KNOXVILLE/KNOX COUNTY METROPOLITAN PLANNING COMMISSION SUBDIVISION REPORT - CONCEPT/USE ON REVIEW

► **FILE #:** 11-SD-17-C **AGENDA ITEM #:** 12
 11-F-17-UR **AGENDA DATE:** 12/14/2017

► **SUBDIVISION:** CASCADE FALLS, LLC ON LOBETTI ROAD

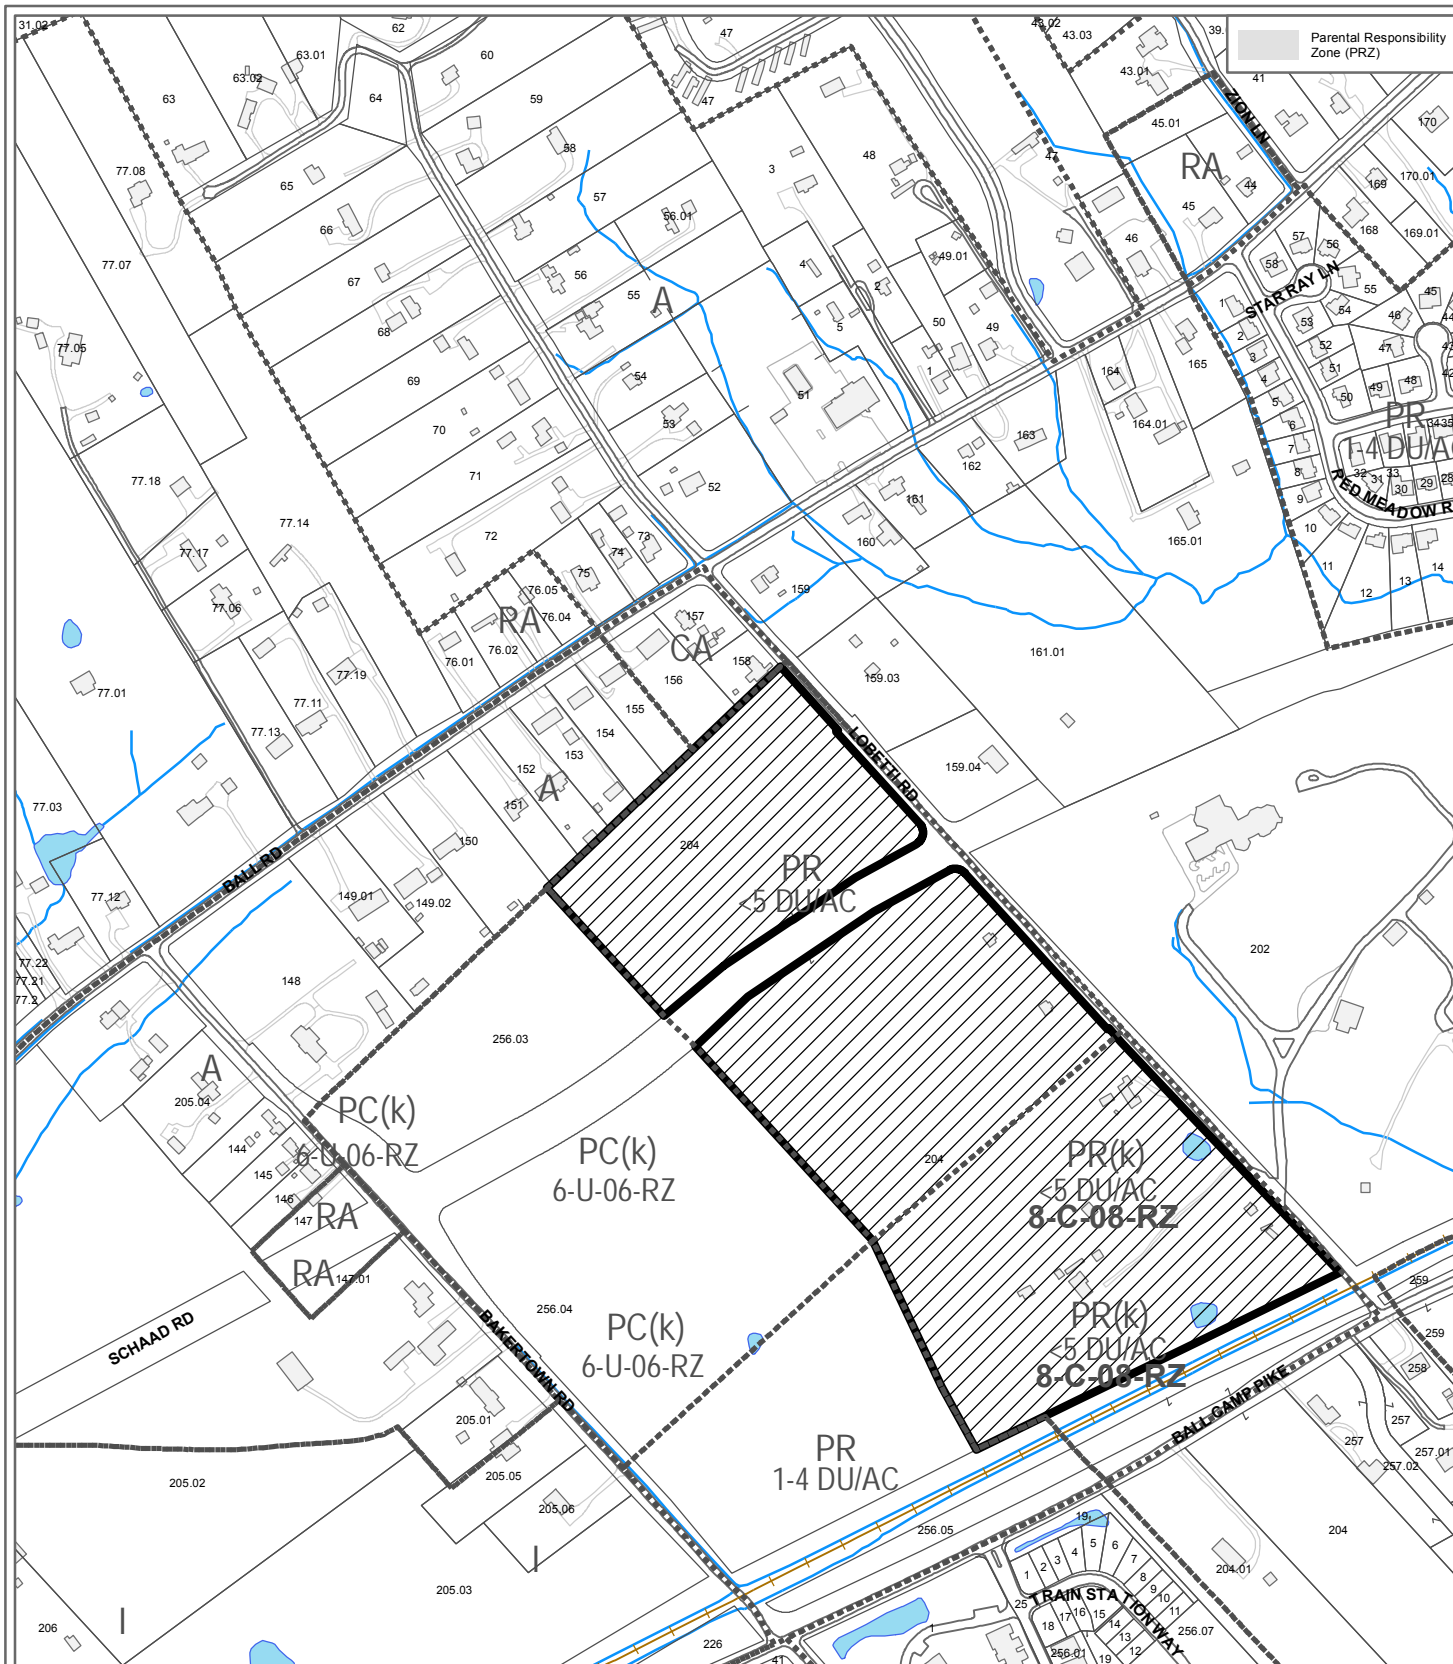
1. Minimum lot frontage on a public street variance for Lots 1-66, from 25' to 19.67'.
2. Roadway width variance for Roads A and B from 26' to 22'.
3. Horizontal curve variance on Road C at STA 16+50, from 250' to 200'.
4. Horizontal curve variance on Road D at STA 8+00, from 250' to 125'.
5. Horizontal curve variance on Road D at STA 19+00, from 250' to 150'.
6. Vertical curve length variance on Road D at STA 15+95, from 159' to 100'.
7. Broken back curves tangent variance on Road G at STA 1+83, from 150' to 65'.
8. Right-of-way reduction variance on Schaad Rd., from 112' to 102'.

4. Revise the concept plan to add a 5' wide sidewalk along the east side of Road C between Road D and the proposed sidewalk along Schaad Rd. with a ramp at the southern end for the crossing of Road D.

- **APPROVE variances 1-8 because site conditions and attached unit design restrict compliance with the Subdivision Regulations and the proposed variances will not create a health or safety hazard.**
